RAMP REPORT REGION 2 ADA 2026

Route 7 – Vine Street
Belfast

CR09025

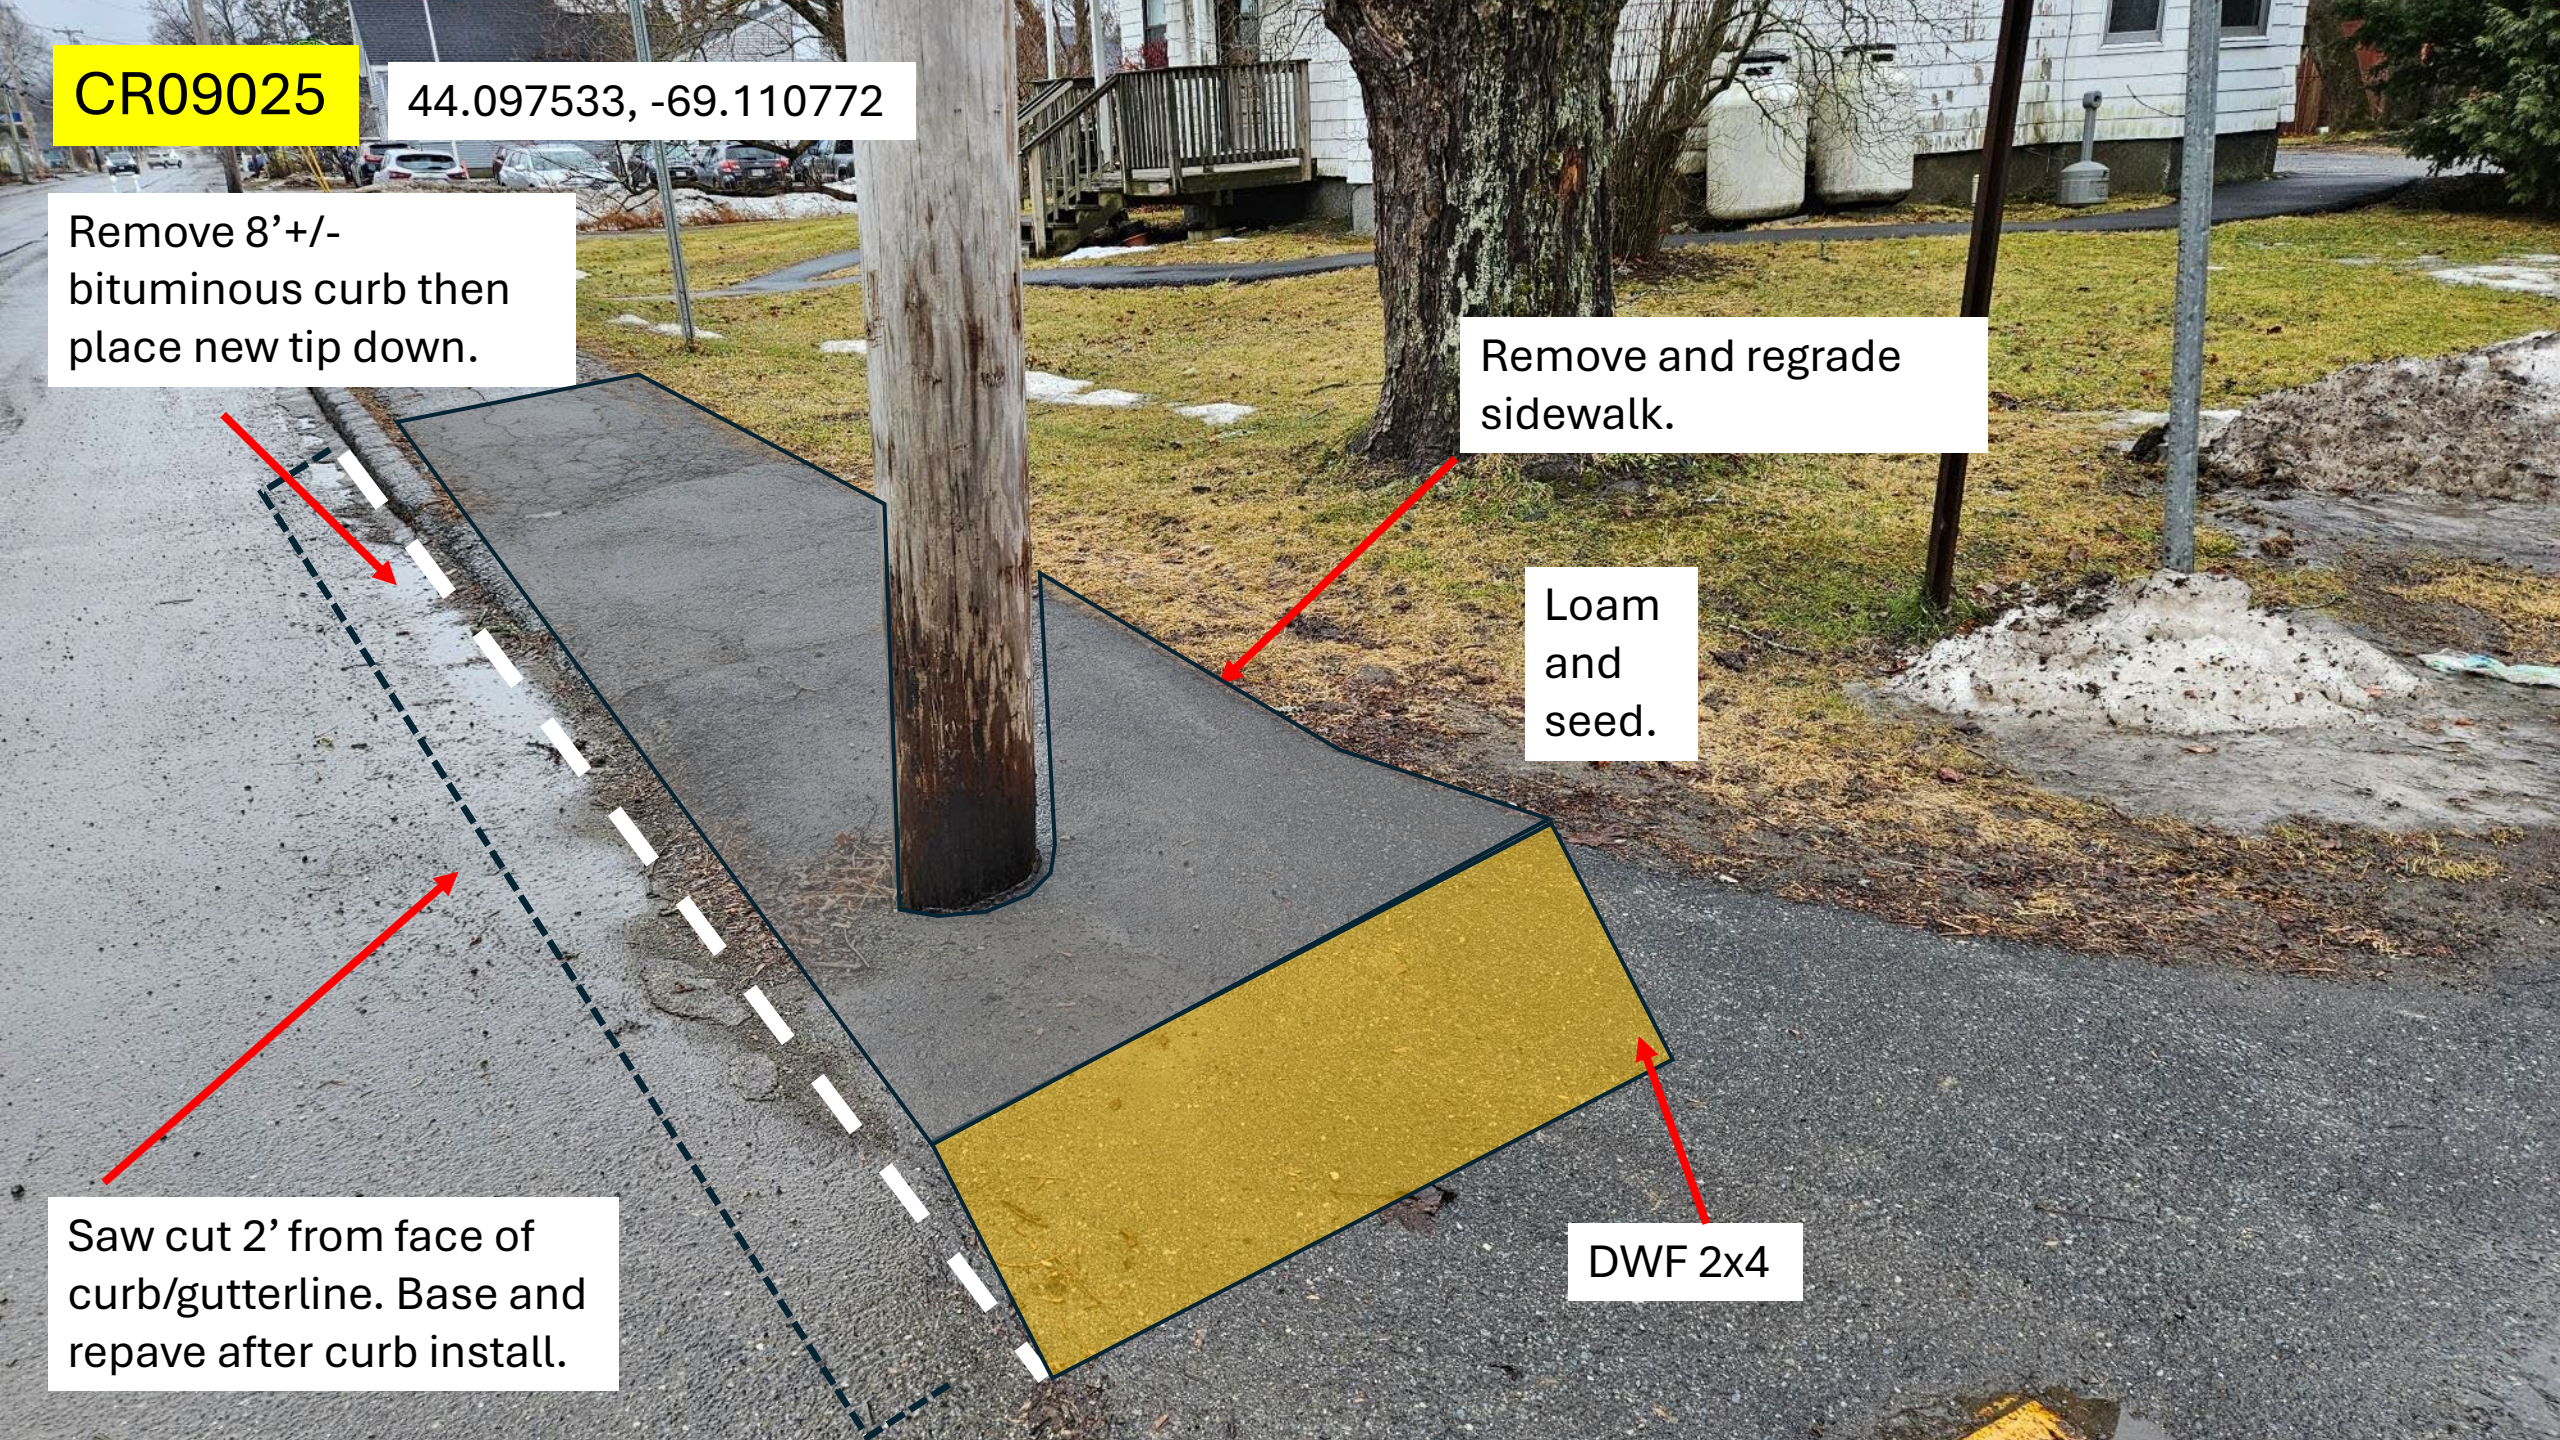
Remove 8' +/-
bituminous curb then
place new tip down.

Remove and regrade
sidewalk.

Loam
and
seed.

Saw cut 2' from
face of curb/gutterline.
Base and
repave after curb install.

DWF 2x4

CR09024

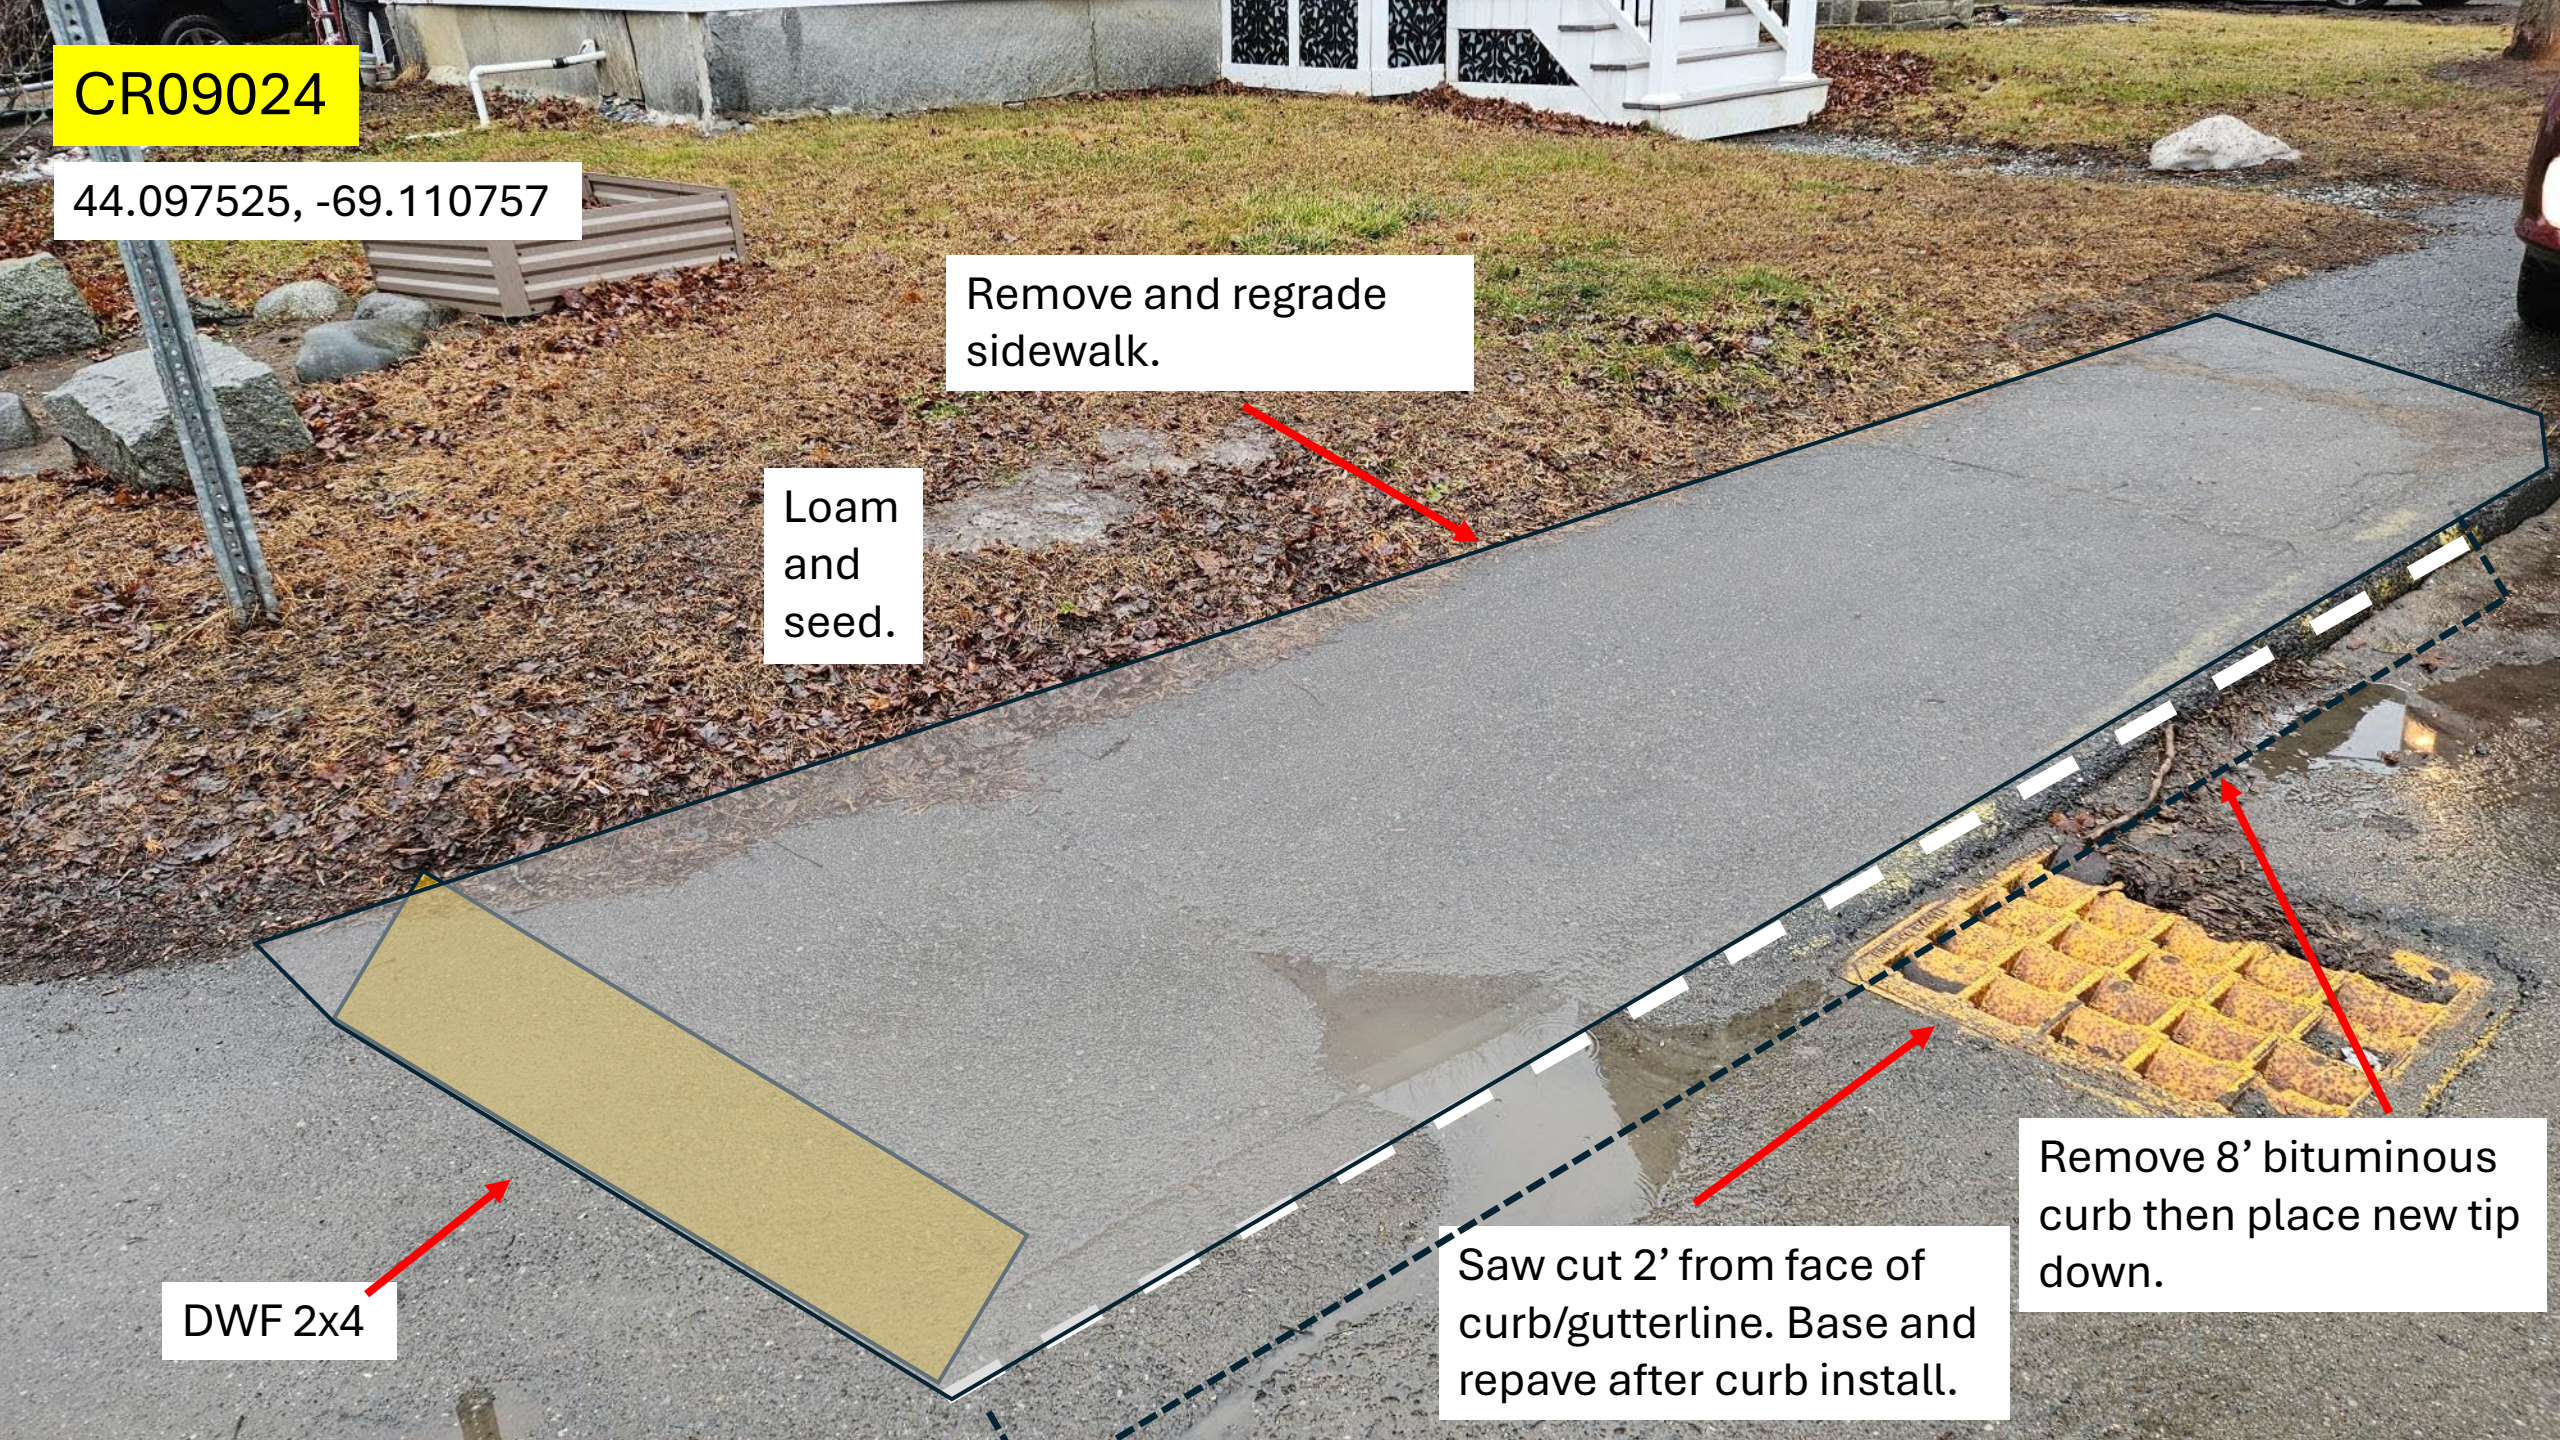
Remove and regrade
sidewalk.

Loam
and
seed.

DWF 2x4

Saw cut 2' from face of
curb/gutterline. Base and
repave after curb install.

Remove 8' bituminous
curb then place new tip
down.

CR09026

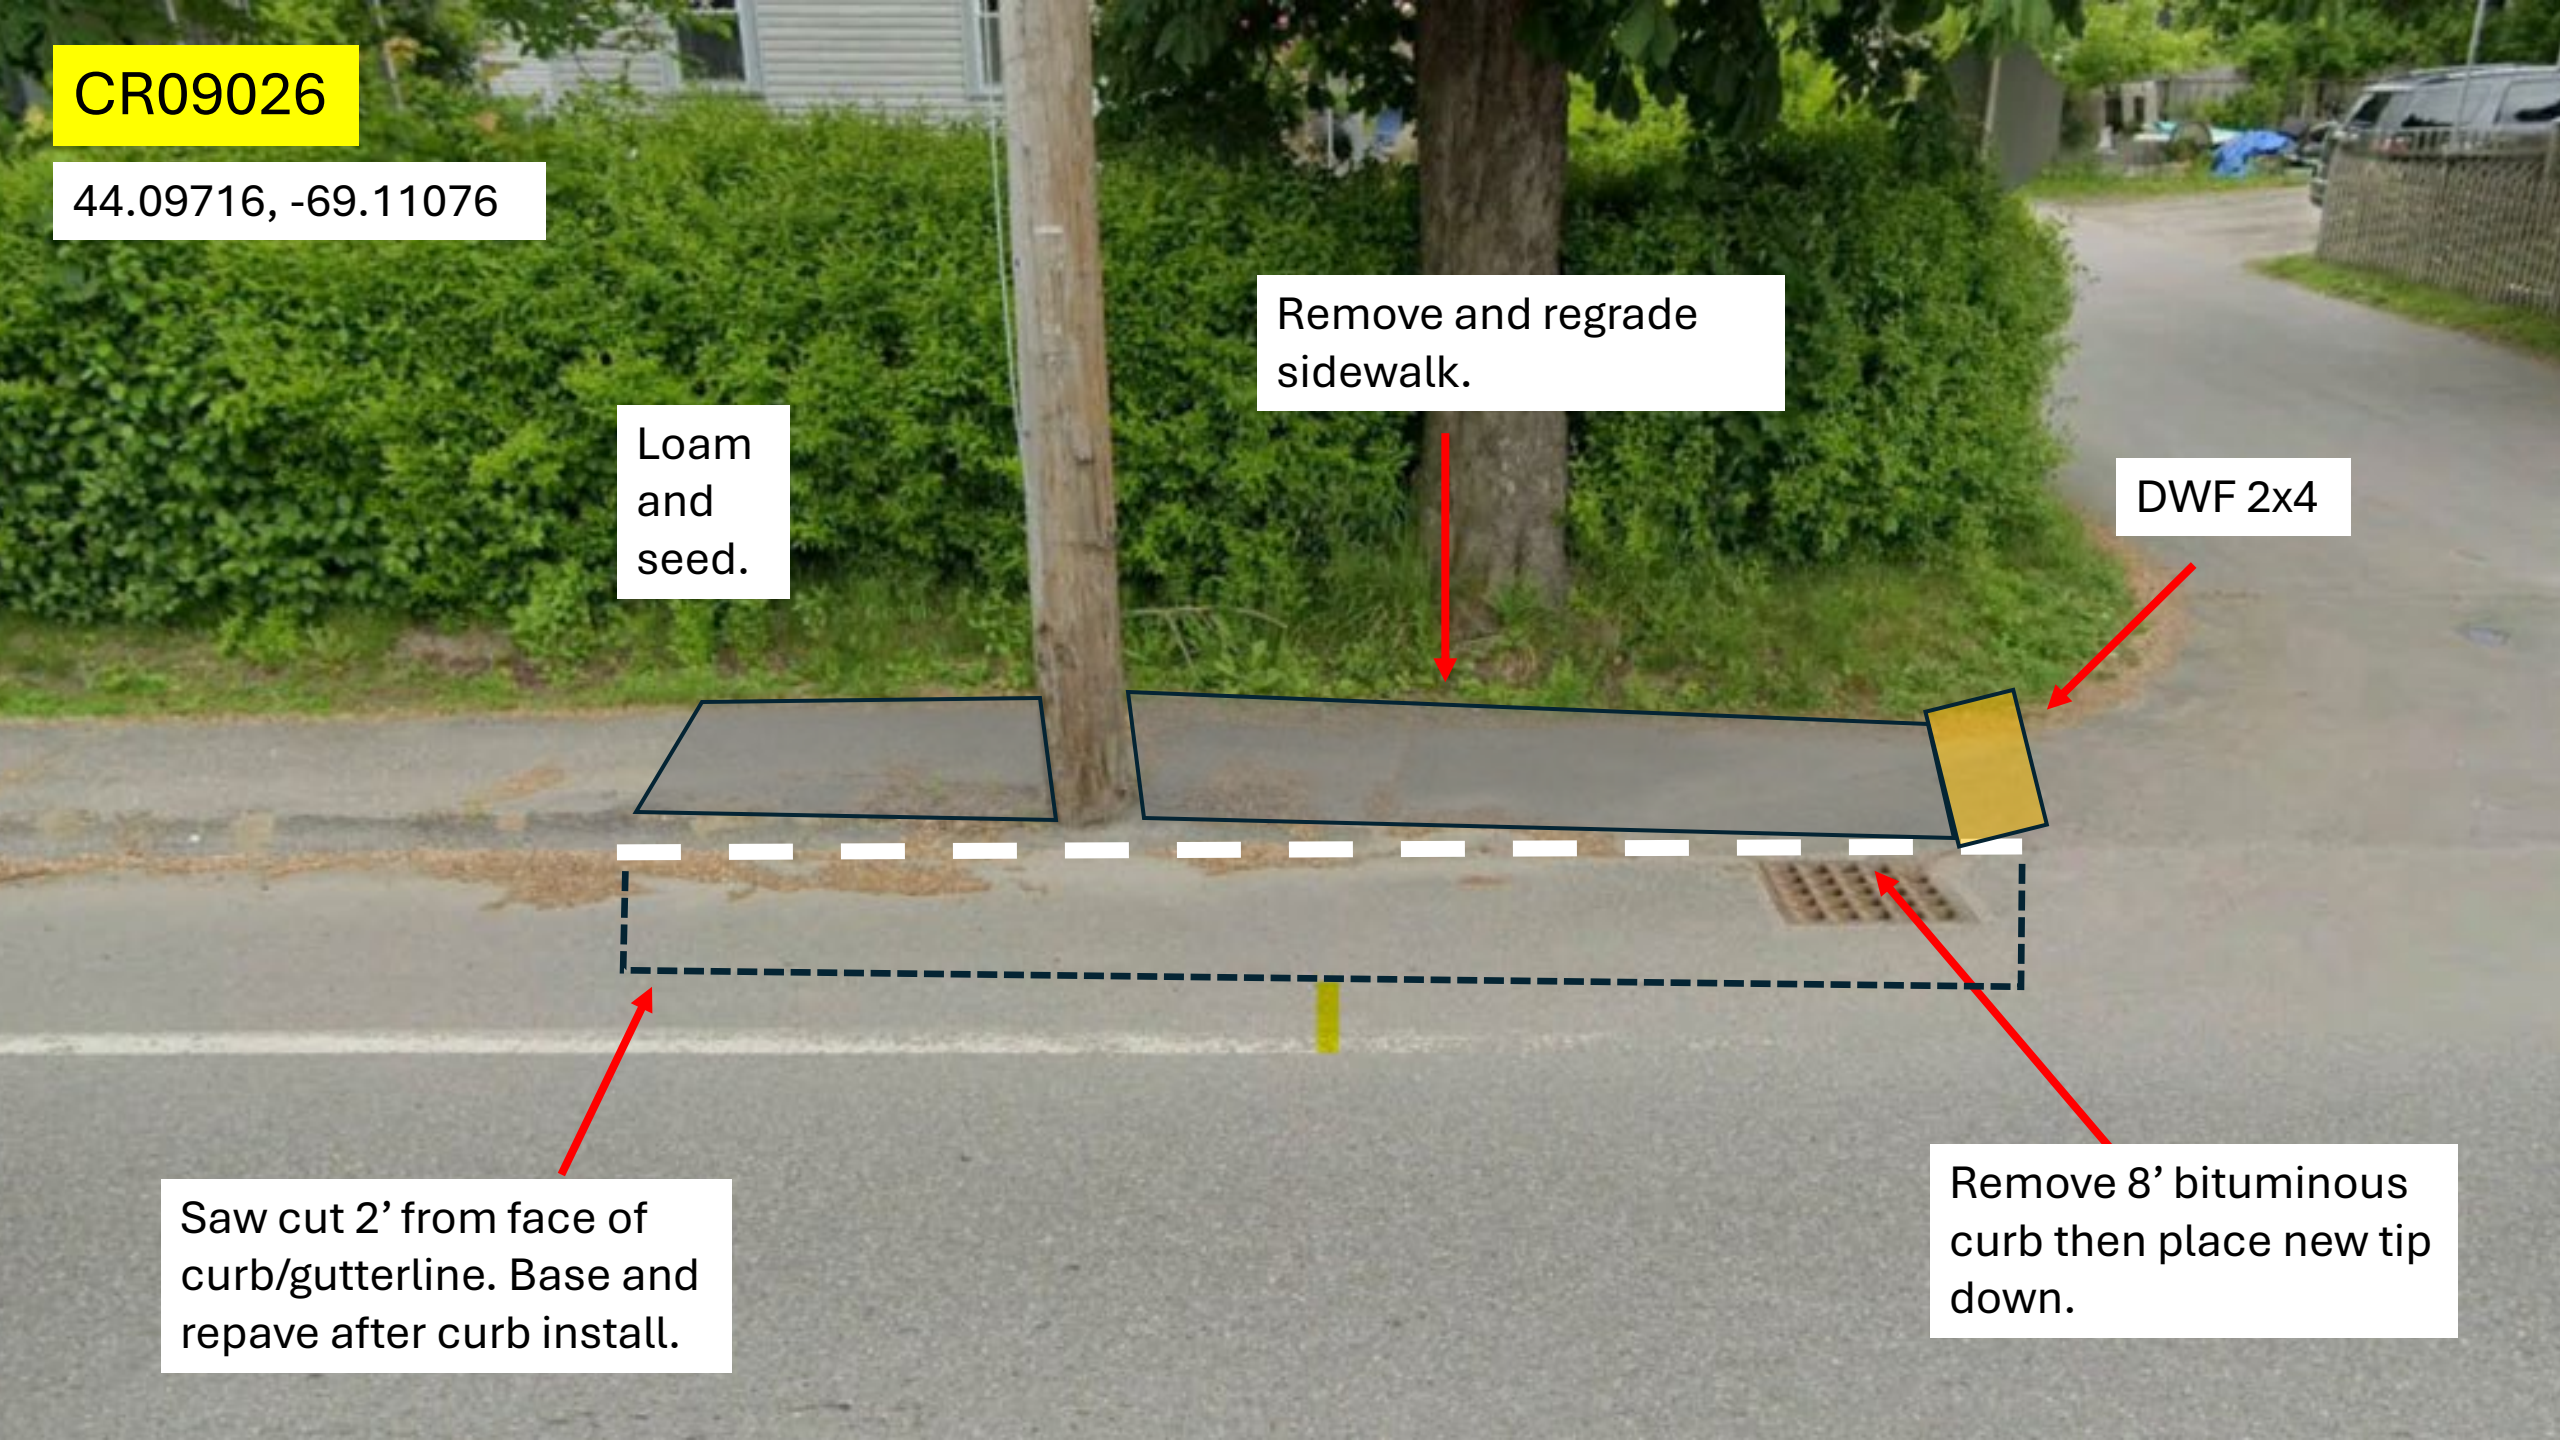
Loam
and
seed.

Remove and regrade
sidewalk.

DWF 2x4

Saw cut 2' from face of
curb/gutterline. Base and
repave after curb install.

Remove 8' bituminous
curb then place new tip
down.
